Re: 2014 Ameren Missouri Draft IRP Chapters 3-6

On behalf of the Sierra Club and the Natural Resources Defense Council, and their members who live, work, and/or recreate throughout Ameren Missouri's service territory, we respectfully submit the following comments and questions regarding draft chapters from the 2014 Ameren Missouri Integrated Resource Plan.

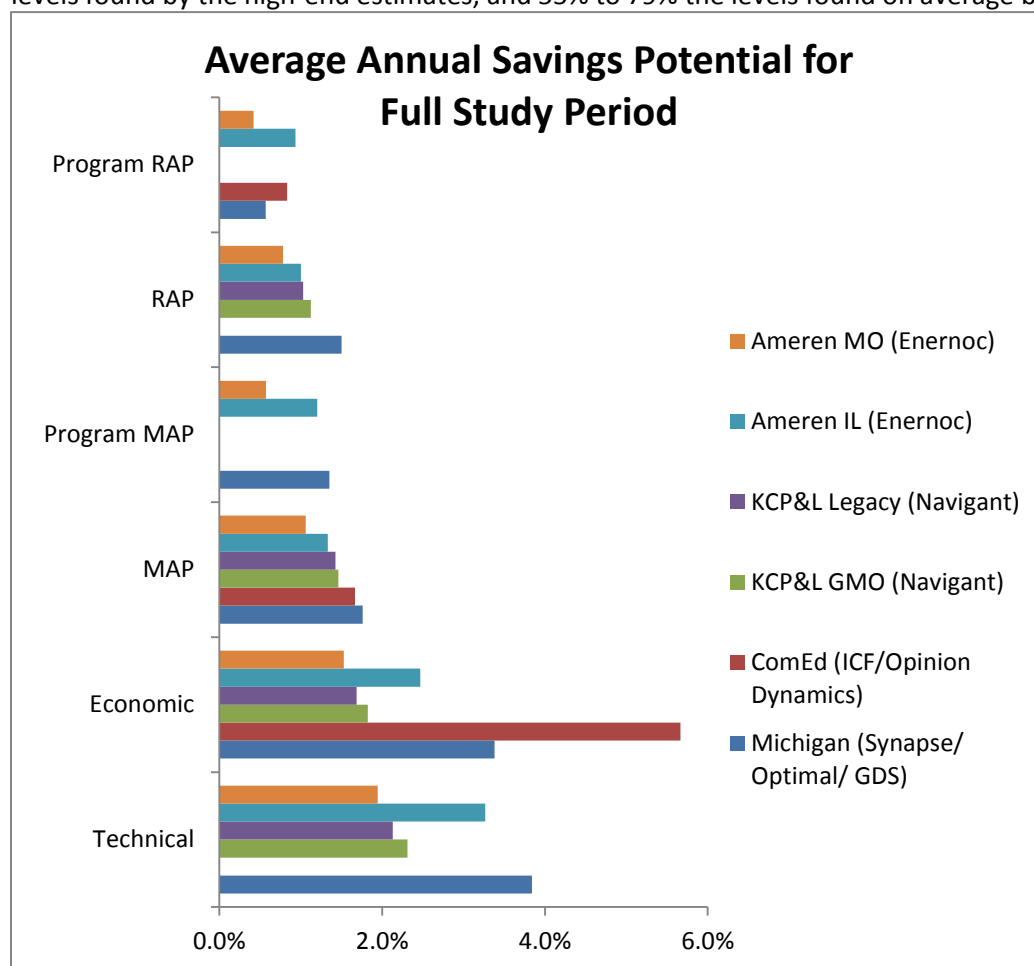
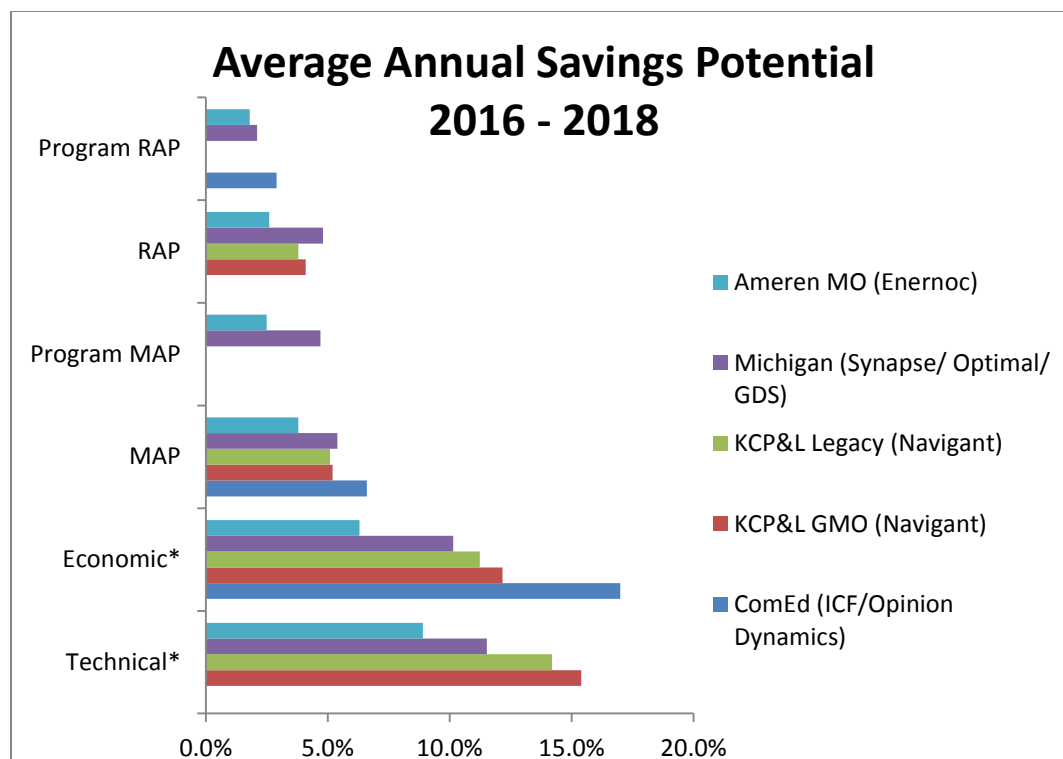
In Table 6.2 of Volume 3 Ameren Missouri’s draft study estimates that the cumulative program level “maximum” achievable savings (MAP) by 2030 is 8.6% and that a more “realistic” level of savings by 2030 is only 6.3%. For the RAP scenario this represents an annual additional savings of approximately .4% of baseline consumption. For MAP, the study assumes .5% annual savings.

For purposes of comparison, the results of recent similar potential studies are in the chart below. This table provides a comparison of recent potential study estimates in nearby jurisdictions. As the chart suggests, Ameren Missouri’s estimates of annual savings are less than potential studies in other recent studies. Comparing across the studies’ full study periods, High end assessments found cumulative savings potentials ranging from 166% to 371% of potentials Ameren MO found. On average, Ameren’s study found only 65% the cumulative total potential its peers found. Comparing just within Ameren MO’s main study period (2016 to 2018), Ameren MO finds potential levels equivalent to 37% to 62% of levels found by the high-end estimates, and 55% to 79% the levels found on average by its peers.
